UNITED STATES PATENT AND TRADEMARK OFFICE

APPLICATION NO.	FILING DATE	FIRST NAMED INVENTOR	ATTORNEY DOCKET NO.	CONFIRMATION NO.
10/733,539	12/11/2003	Timothy A. Tamcsin	20030317.ORI	2641
23595	7590	06/06/2005	EXAMINER	
NIKOLAI & MERSEREAU, P.A. 900 SECOND AVENUE SOUTH SUITE 820 MINNEAPOLIS, MN 55402			MILLS, DANIEL J	
			ART UNIT	PAPER NUMBER
			3679

Office Action Summary	Application No. 10/733,539	Applicant(s) TAMCSIN, TIMOTHY A.	
	Examiner Daniel J. Mills	Art Unit 3679

DETAILED ACTION***Drawings***

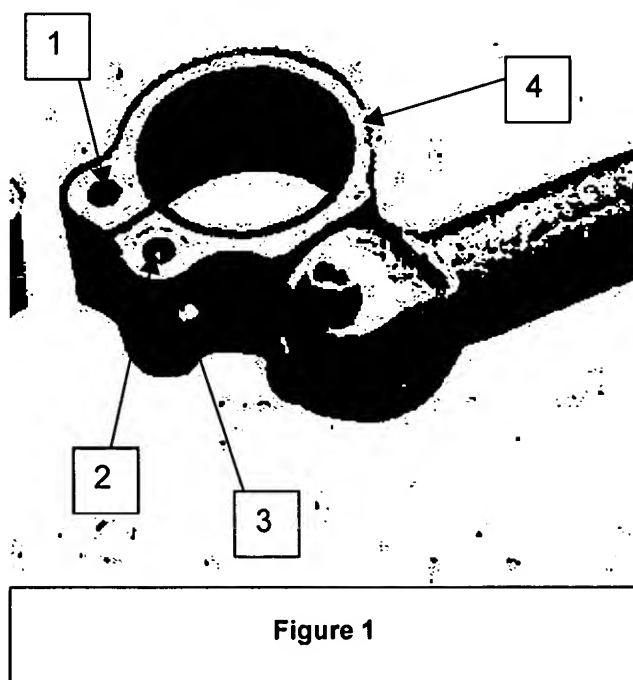
Twobros (see Figure 1 in this action) teaches a split ring clamping arrangement in which a locking portion integral with the split ring has a first post aperture (2) and a second post aperture (1), one on either side of a gap in the split ring, and a bolt aperture (shown by the positioning of bolt 3) through the locking portions, a first post having a smooth wall aperture there through and a second post having an aperture with a

threaded wall there through (this is clearly true from the illustration), and a bolt (3) for extending through the locking portion apertures and the posts for engaging the threads of the second post to adjust the size of gap between the locking portions. This arrangement is taught as useful to distribute the clamping load over the entire split ring. Accordingly it would have been obvious to one of ordinary skill in the adjustable handle bar clamp art at the time of applicant's invention, to modify an arrangement as disclosed by Kobacker to include a clamping arrangement as taught by twobros for the purpose of evenly distributing the clamping load.
